From: Manoj Nathoo (AT)
Sent: Wednesday, 30 April 2025 9:38 am
To: Siobhan O'Donovan (AT)
Subject: FW: Cross St/East St/Canada IFC

Cross St – Big Picture

OVERVIEW DESIGN

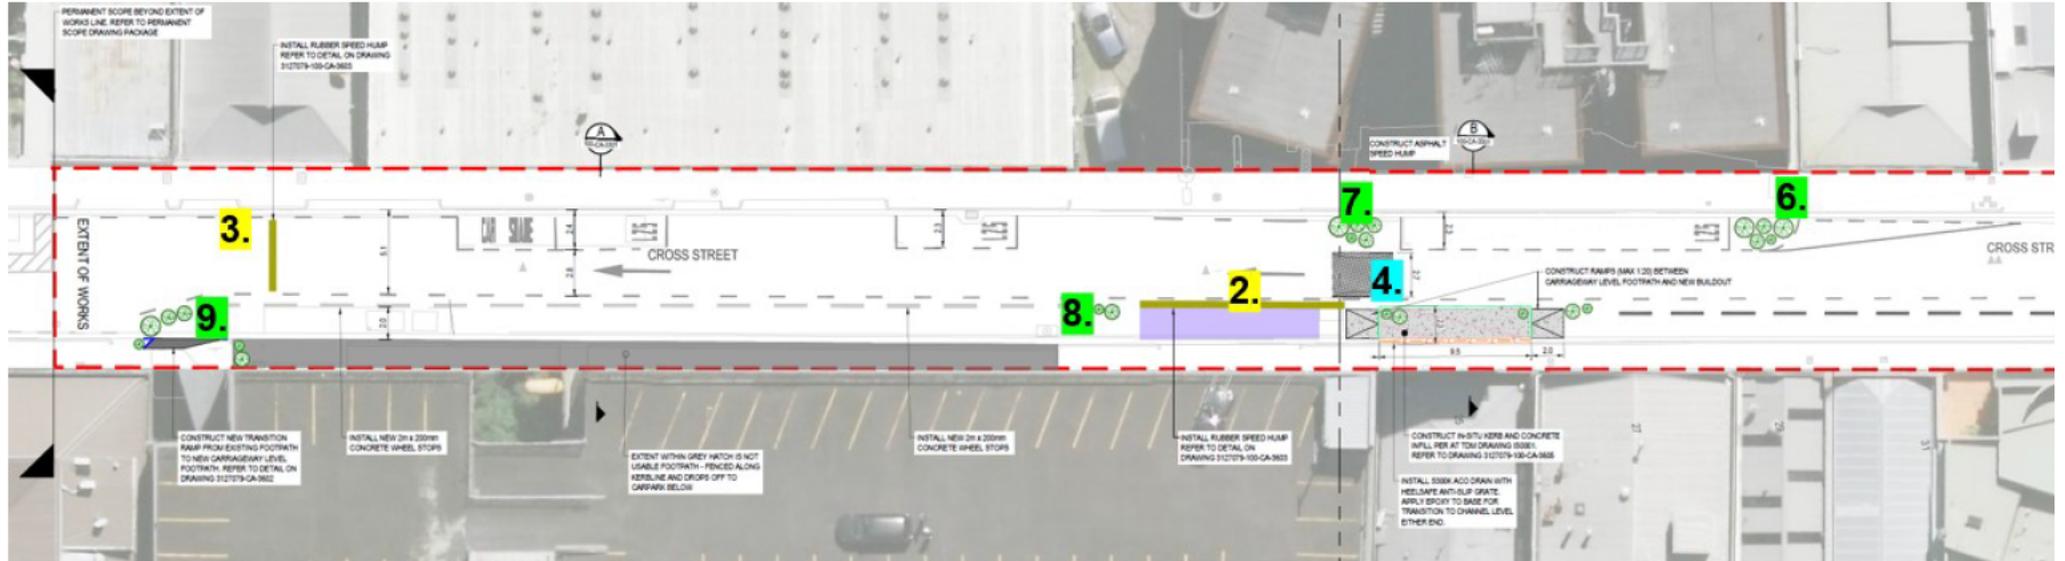
Based on the contour it seems manageable to maintain the speed along Cross St because no downhill-uphill forces. Removing the vertical features such as the speed hump and speed cushion on Cross St is acceptable if the operating speed can achieve the targeted speed around the station, which is a local road station access.

I would also like to point out that the **kerb build-out (horizontal features), still needs to be included on the design.**

It helps to create a clear delineation between the live traffic lane and the kerb-side loading or parking activity (when there is no loading/parking vehicle).

Rubber speed hump

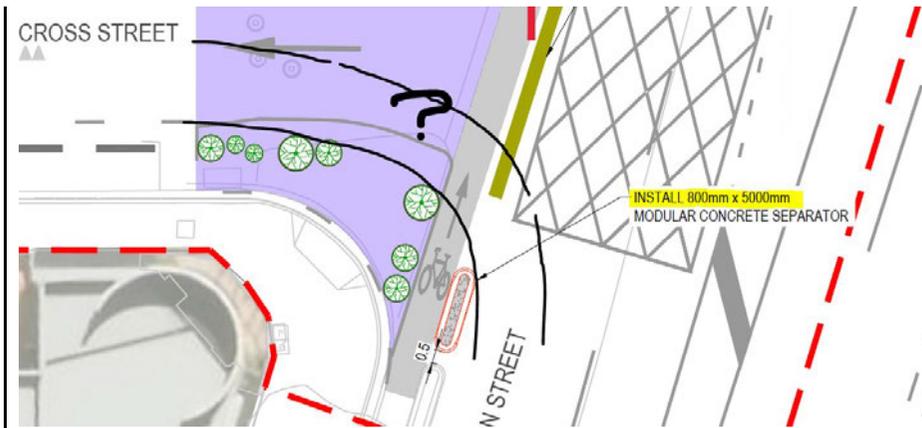
- 1 and 3: main vehicle movement
- 2: only for vehicle entering the car park building

Rubber speed hump#1 – can be removed

Located in the intersection, a tight turning radius has already helped reduce/manage the speed (retain the additional 800mm concrete separator and planter box #5).

LEFT TURN FROM UPPER QUEEN STREET TO CROSS STREET

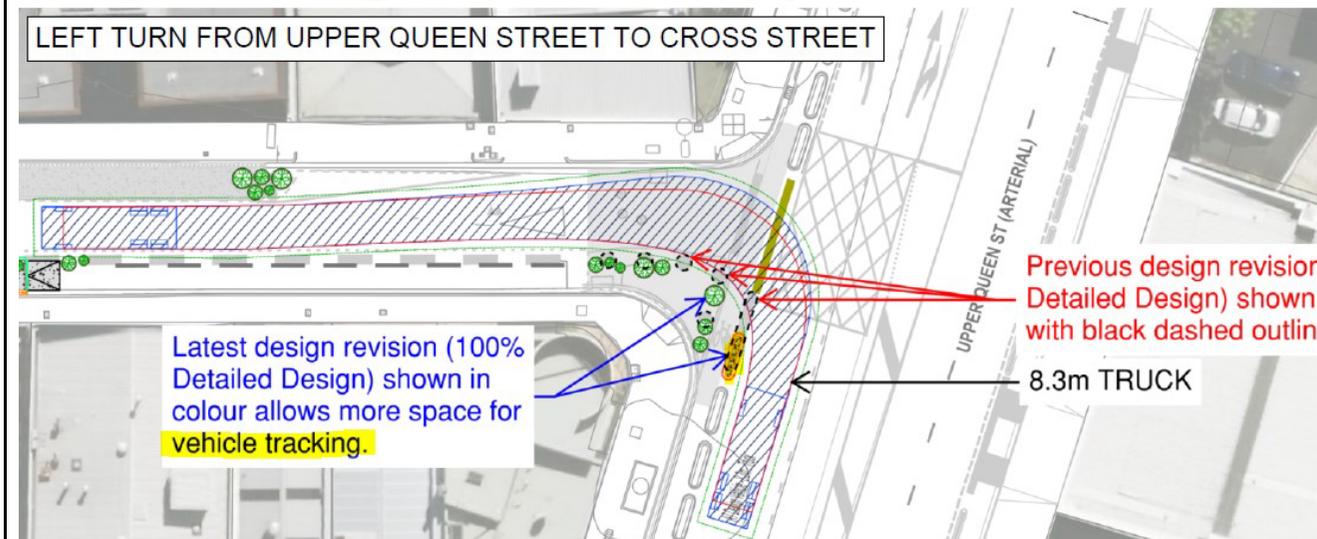
Speed cushion

- 4 (only one between $\pm 55m$ and $\pm 65m$ distance to both of speed humps)
- Subject to operating speed (however tend to agree on managing speed, also can be achieved by having kerbside activity (loading zone, a

Rubber speed hump#2 – can be removed

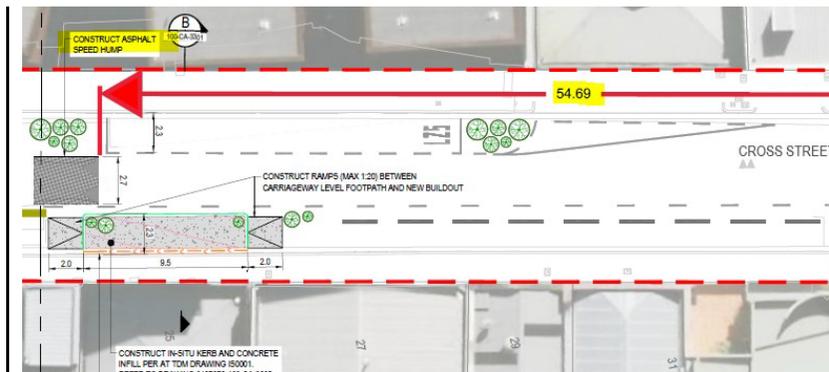
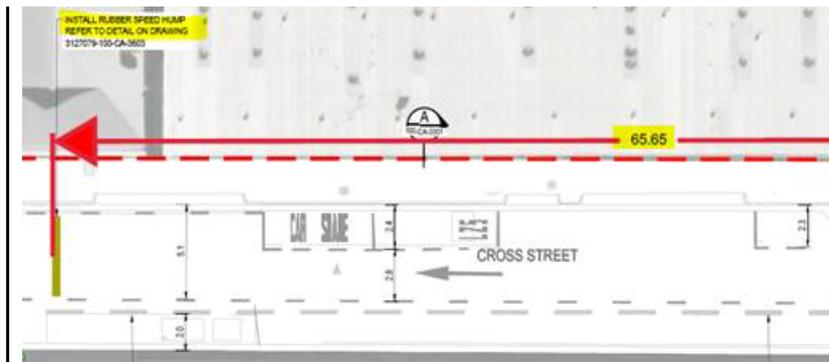
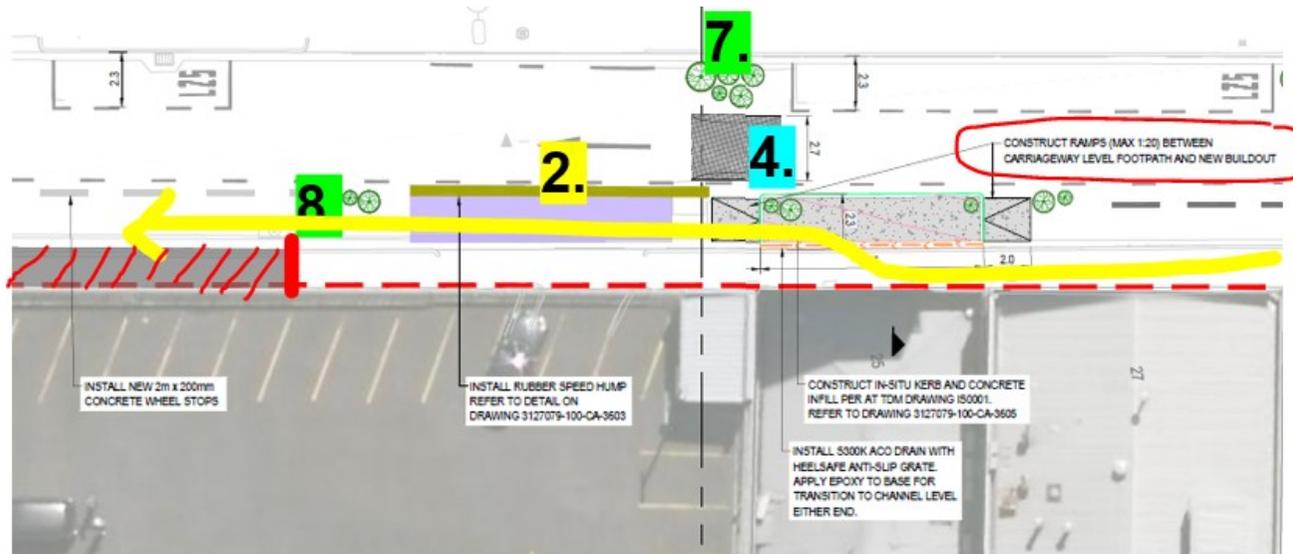
Previously served the shifting of pedestrians from the kerb build-out (see yellow line), the rubber hump is an additional design treatment to ensure drivers slowly enter the car park building.

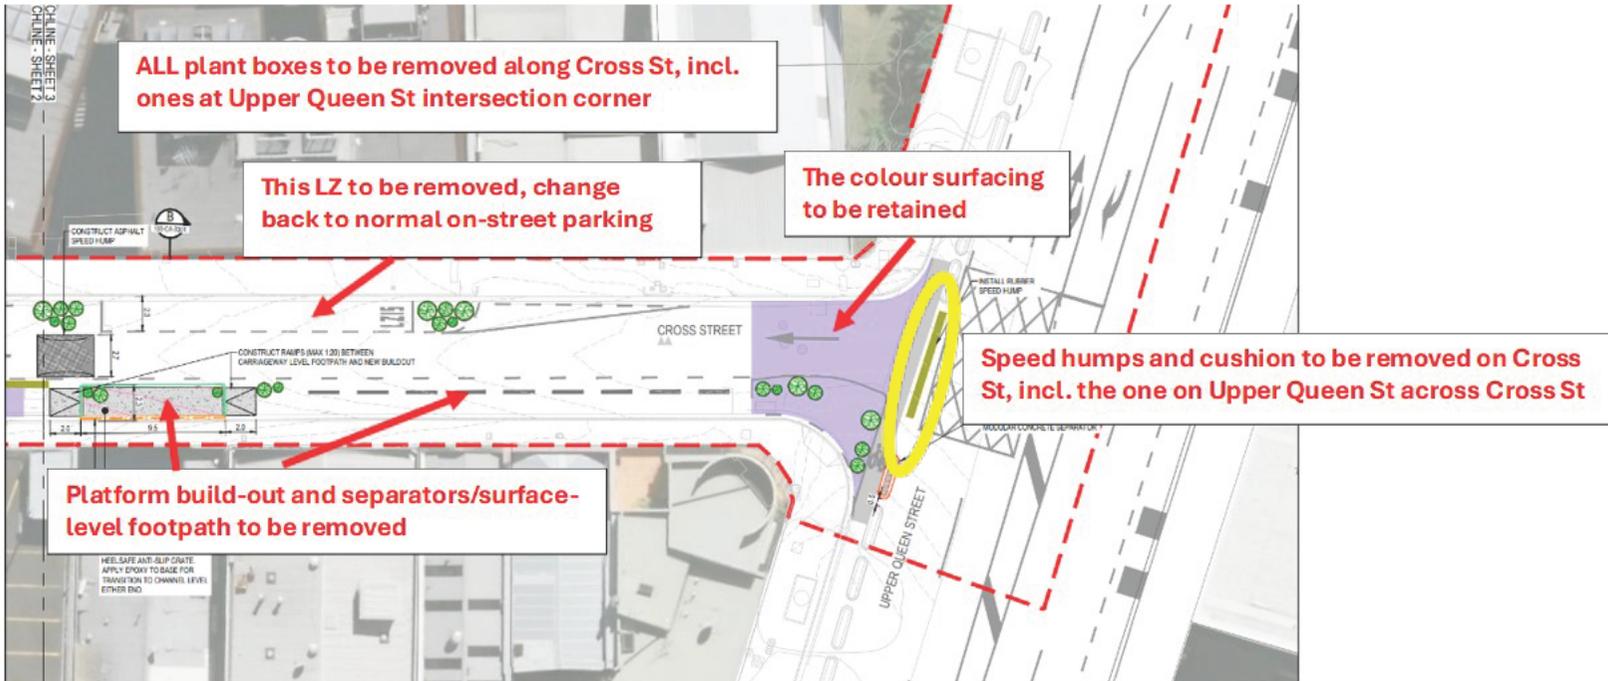
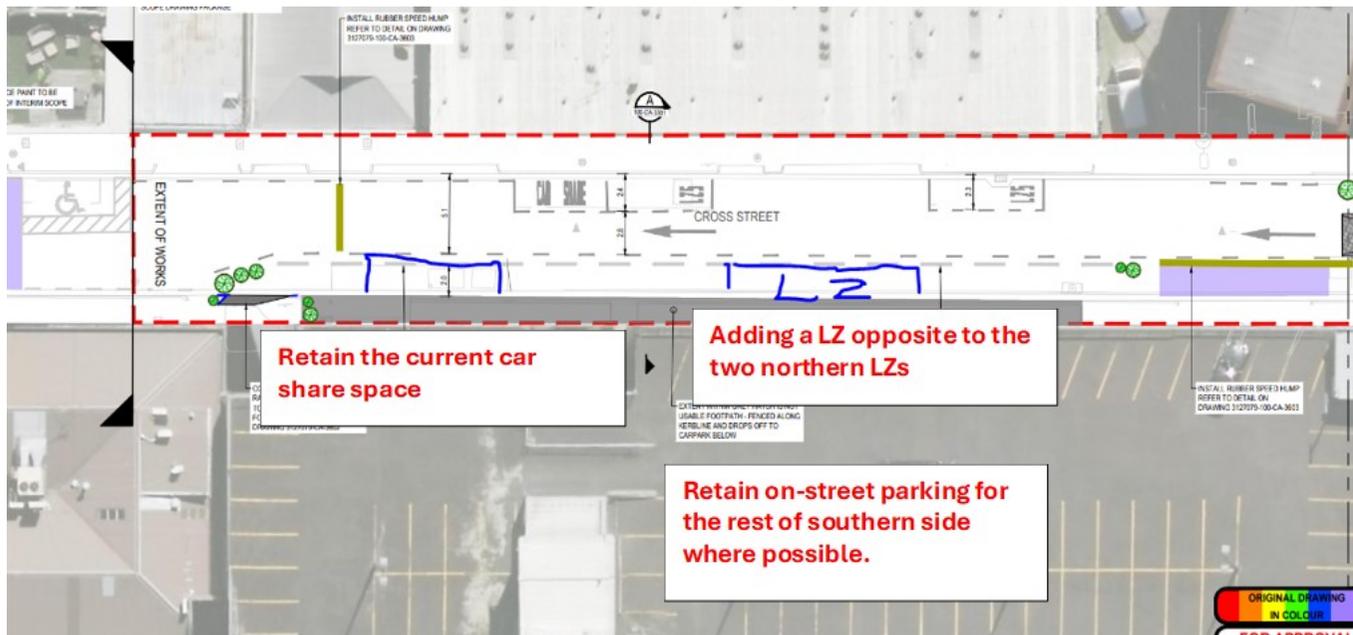
Another item the project team wish to draw your attention is that the speed hump across Cross Street at Upper Queen St intersection is to be removed (yellow circled in the snip below) along with other vertical devices along Cross Street, which was strongly suggested by Murray Burt due to the unpleasant experience and damage it may cause to the turning traffic, especially the delivery trucks. You can refer to pg. 6-7 in the Engineering Package attached for the original Cross St design, and the snips below showing the changes that were recommended and endorsed by Murray. The project team would like to check with you as the key SMEs to this particular item, if any of you have any major concern on the changes. If yes, please kindly provide us a strong justification for keeping any original proposal, for our further engagement with Murray Burt and project PCG.
